Meeting Agenda

Historic Zoning Commission

Monday, September 30, 2024

ALL WINDOWS AND DOORS
TO BE WOOD SDL UNLESS
NOTED OTHERWISE

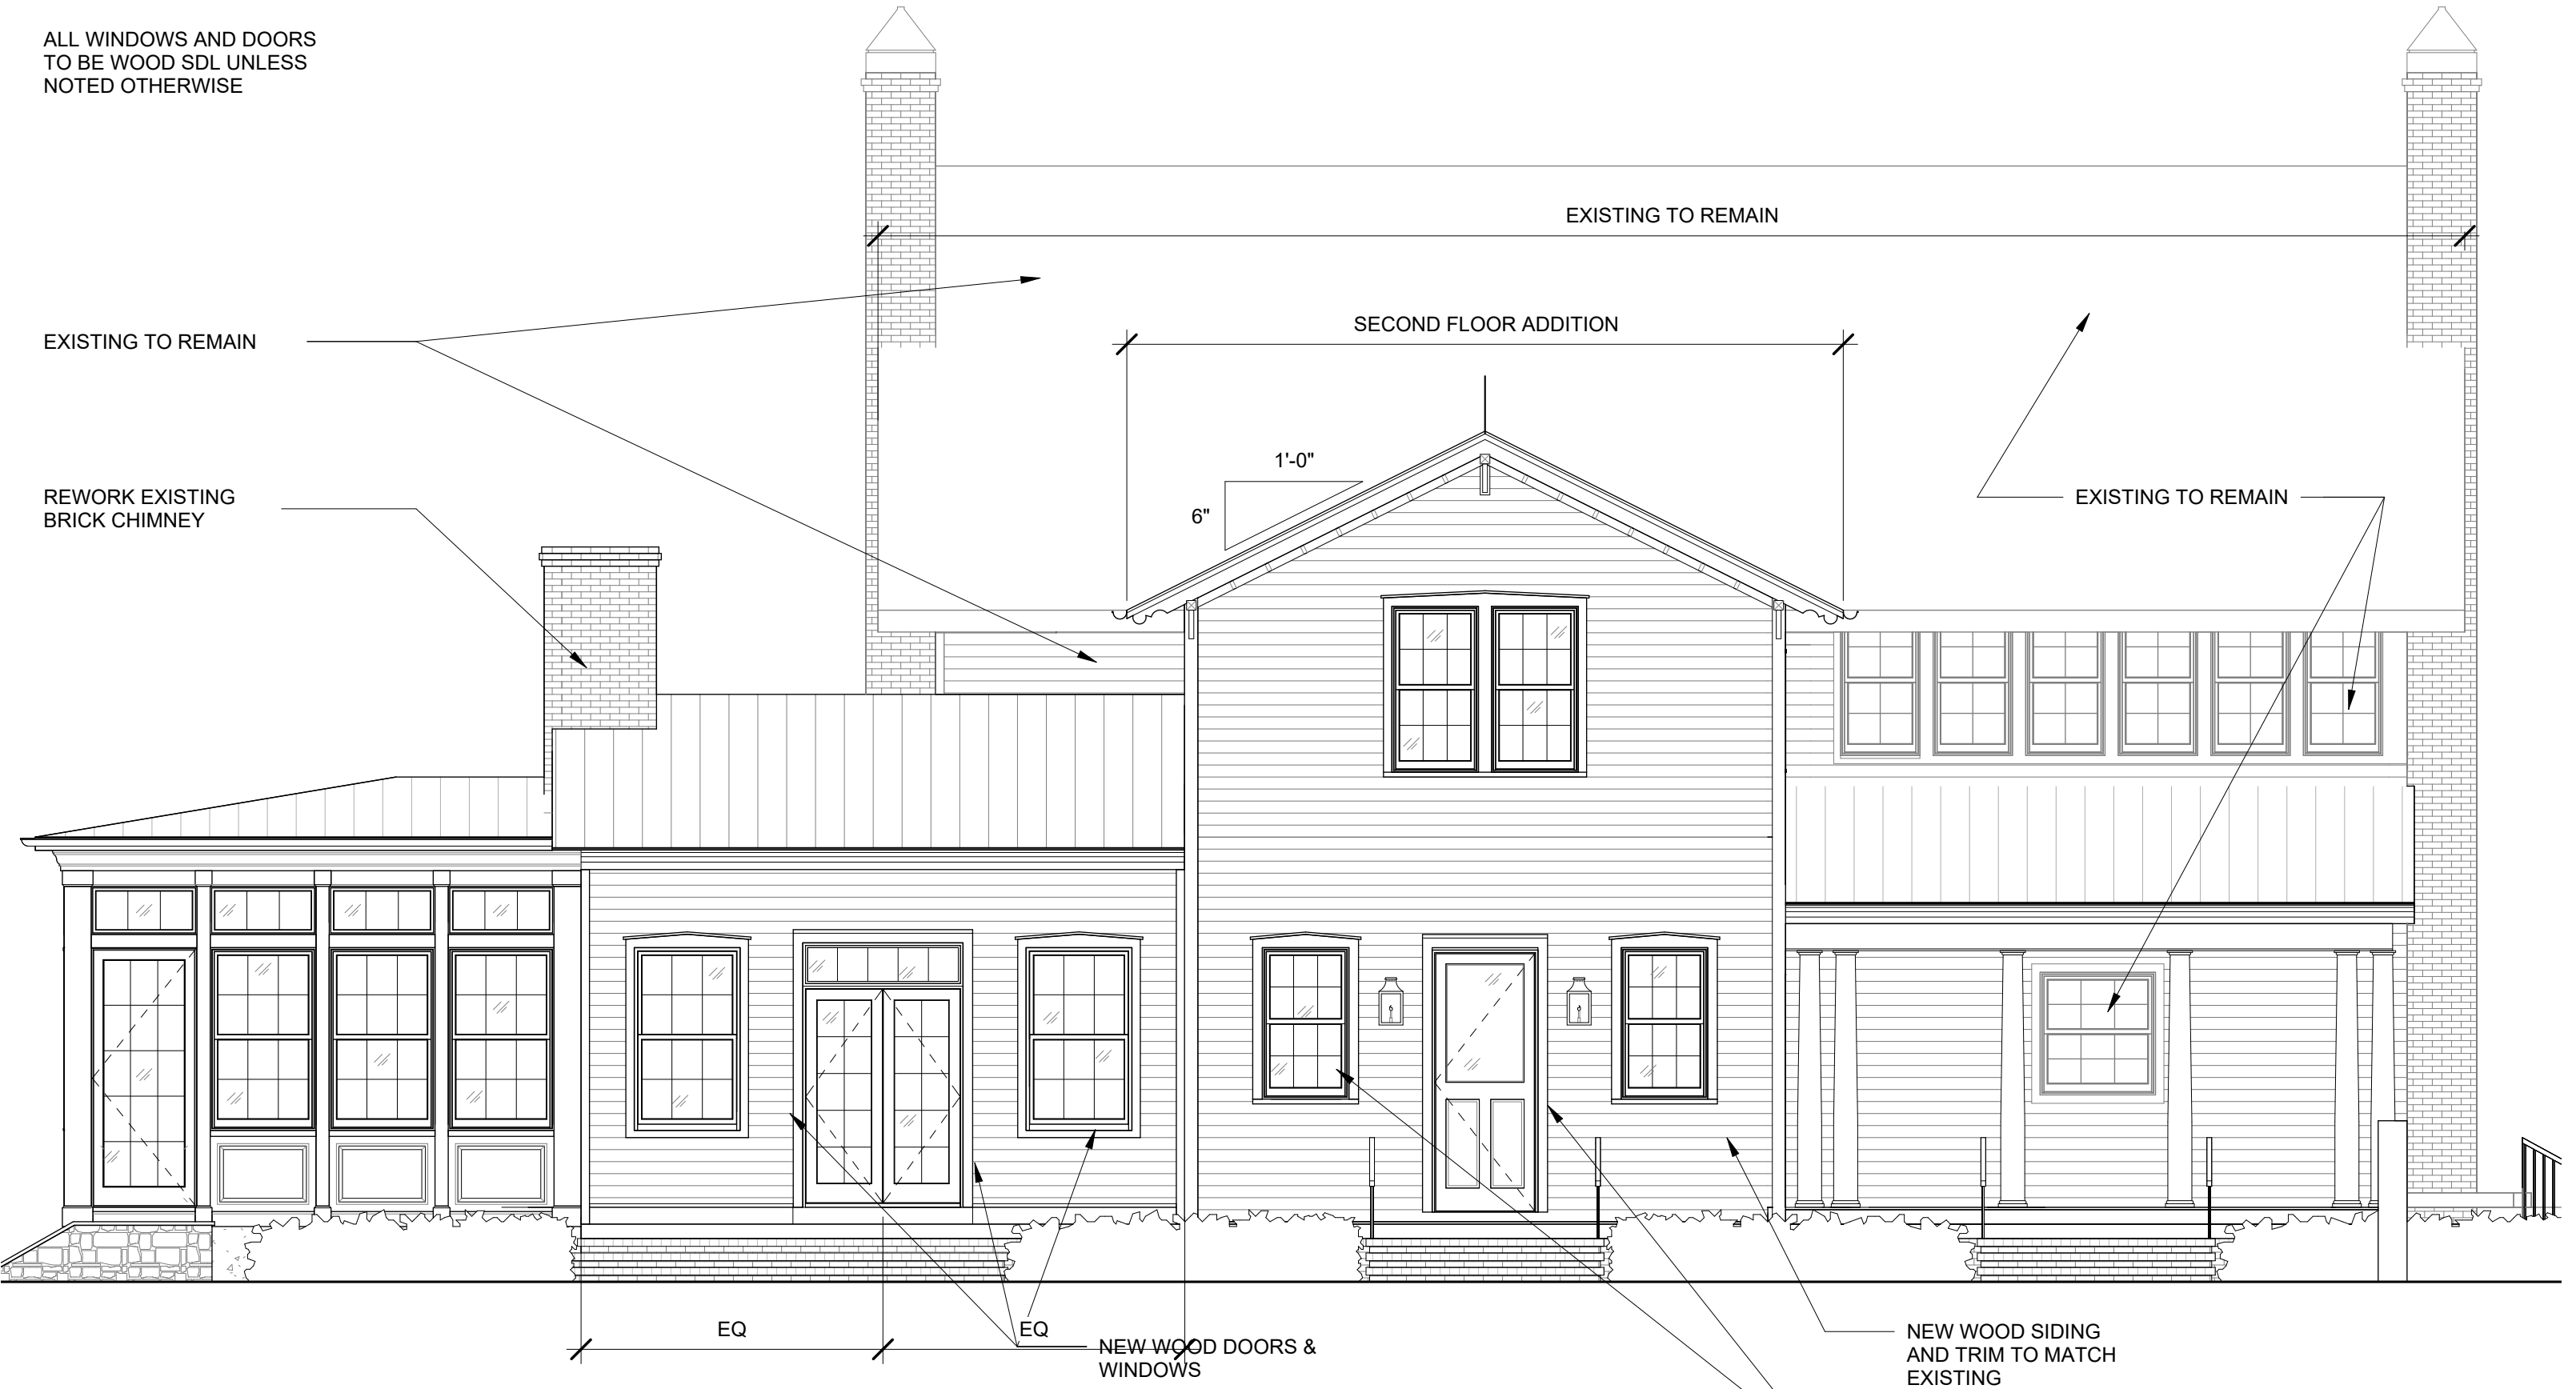
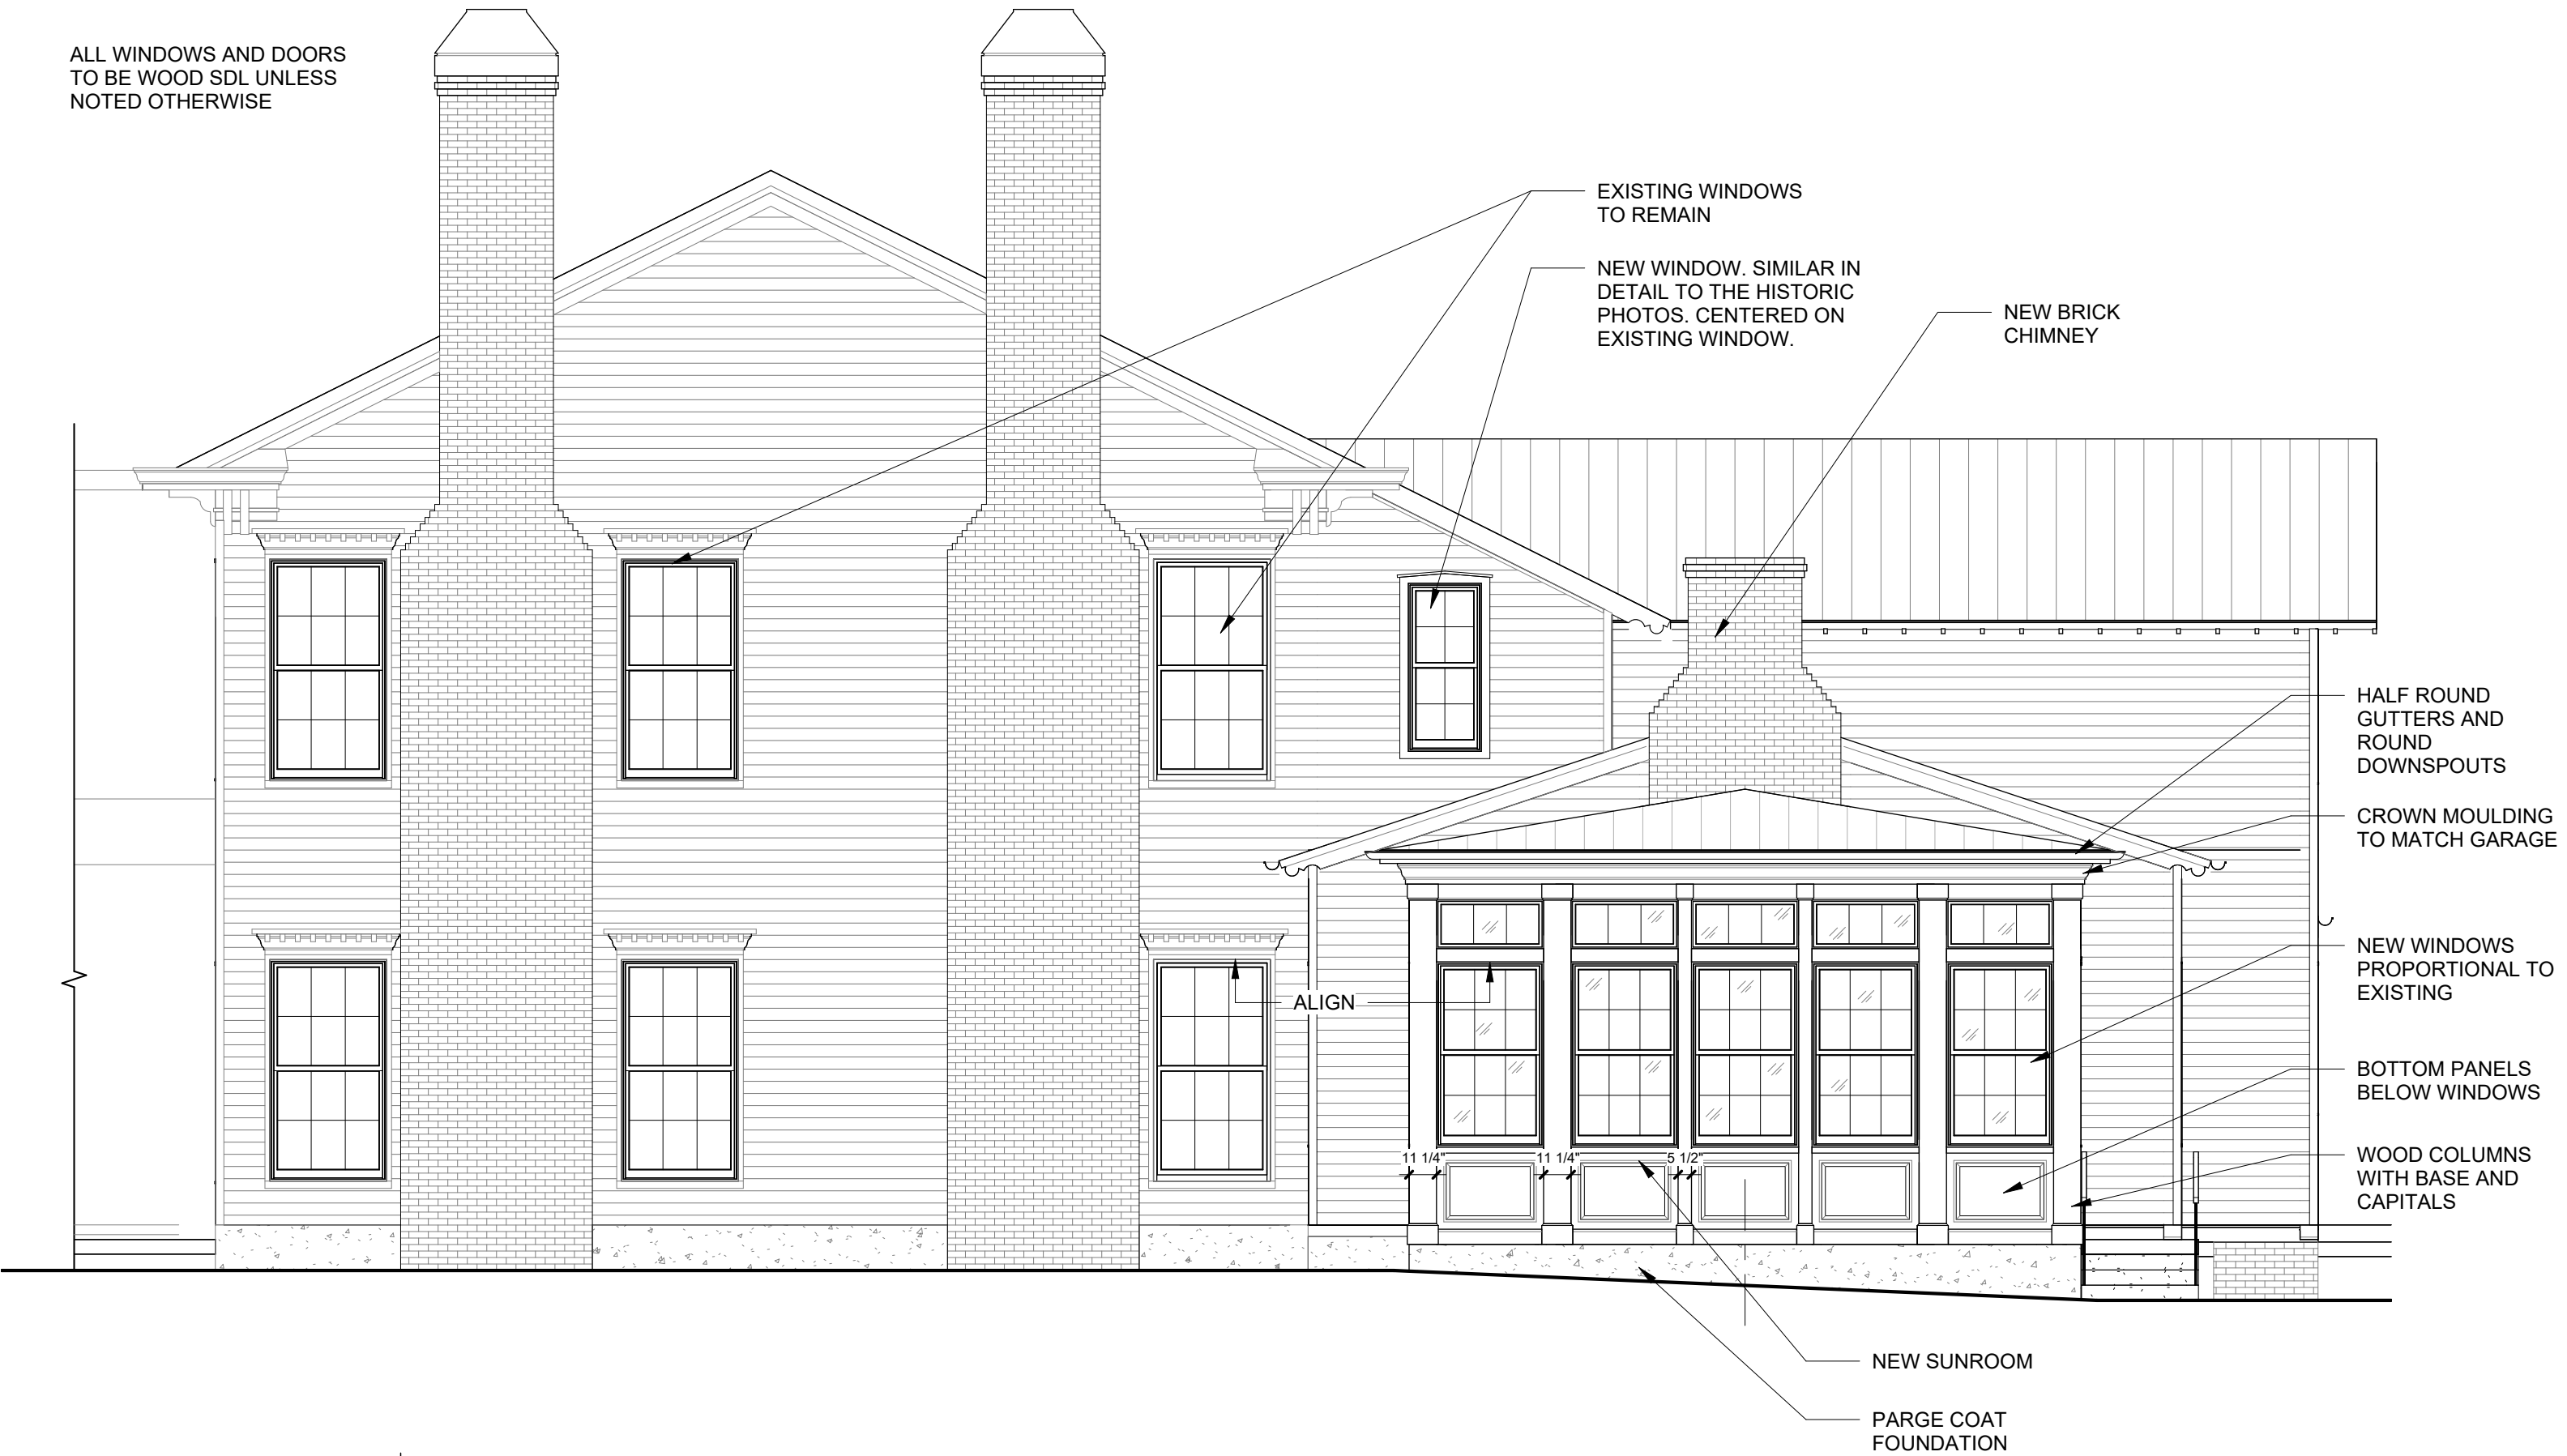
The proposed addition would add approximately 927 sq. ft. to the footprint of the home. The existing historic footprint of the home is 2,133 sq. ft. The addition is appropriately sized, being 43% of the historic footprint. The Guidelines recommend that additions be subordinate to the historic building and should not exceed 50% of the historic building's footprint. The addition, along with all of the structures, equates to a total lot coverage amount of 0.02%. This is appropriate as the Guidelines recommend not to exceed 35% of lot coverage. The orientation, form, and size of the addition that is being proposed are appropriate.

The rhythm and placement are traditional and provide continued symmetry that is typical to the neoclassical style. The windows are more compatible in size and detailing to those on the historic building.

1. Window specifications showing three-dimensional cut-outs with dimensions must be provided to the Preservation Planner before the Building Permit submittal.
2. The reveal of the siding on the addition must match the existing siding on the building.
3. The application must meet all the requirements of the City of Franklin prior to issuance of a building permit.
4. Any additional changes to the approved plans must be returned to the Preservation Planner or the Historic Zoning Commission for review and approval.
